Subject: Freezer drawer gasket not sealing completely at the top left corner.

SERVICE BULLETIN	
Product:	French Door Refrigerators
Bulletin Date:	9/10/2014
Bulletin Number	ASC20140910001
Models:	RF28HDEDBSR/AA RF28HFEDBBC/AA RF28HFEDBSR/AA RF28HFEDBWW/AA RF28HFPDBSR/AA RF28HMEDBBC/AA RF28HMEDBSR/AA RF28HMEDBWW/AA RF28HMEBBSR/AA

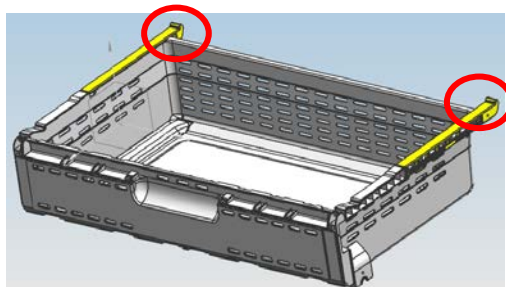
Symptom: Condensation and frost forms at the top of the freezer due to a gap between the freezer door gasket and the cabinet.

Condensation

Gap

Root Cause: The rear wall of the freezer compartment is bowed out approximately 8.8mm. The upper freezer tray rail hits the bowed area, preventing the drawer from closing properly.

New assembly with new style rails

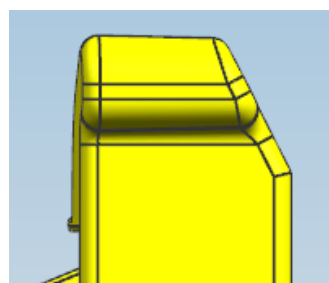
- Open the freezer drawer and remove the upper tray.
- Inspect the rear corners for a bowed section in the liner.
- If the bowed section is present, replace the upper tray with the new part, DA97-08439D, which includes rails that allow for proper clearance at the bowed area. The left and right rails have been redesigned.

Old Rail

New Rail

Part Code: DA97-08439D

- The redesigned upper tray is used in all new units beginning with June, 2014 production.
- The manufacturing process has been adjusted to reduce the likelihood of liner imperfections.
